UNITED STATES PATENT AND TRADEMARK OFFICE

APPLICATION NO.	FILING DATE	FIRST NAMED INVENTOR	ATTORNEY DOCKET NO.	CONFIRMATION NO.
09/869,813	01/03/2002	Lawrence M. Boyd	4002-2734	1340

Office Action Summary

DETAILED ACTION

ATTACHMENT A

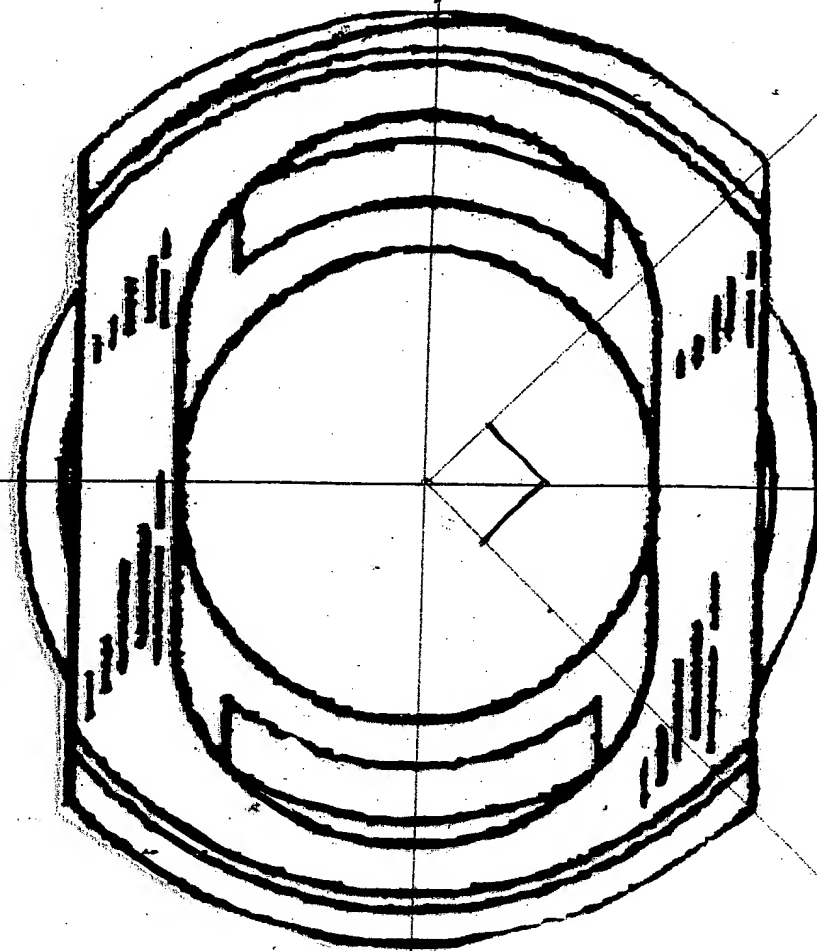
disposed within the chamber (see col. 5, lines 55-59 and col. 7, lines 50-58). Each side wall discontinuity appears to extend over approximately 25% of the circumference of the body (see Attachment A, corresponding to Fig. 4). The side wall discontinuity appears to extend over at least 80% of the length of the body (see Fig. 2). Osteogenic material could be introduced through the openings 24,25. Zdeblick also discloses preparing adjacent vertebrae and placing the devices in the intervertebral space to nest against each other (see col. 7, lines 50-58 and col. 10, line 48 - col. 11, line 51 and Fig. 6). It is also disclosed to pack osteogenic material prior to or after implanting the devices, i.e. "additional bone graft material" where "additional" implies some was added before implantation while the "additional" amount was added "in situ" (see col. 5, lines 55-59 and col. 7, lines 50-58).

Appears to be approx.
90° or 25% of the
Circumference.
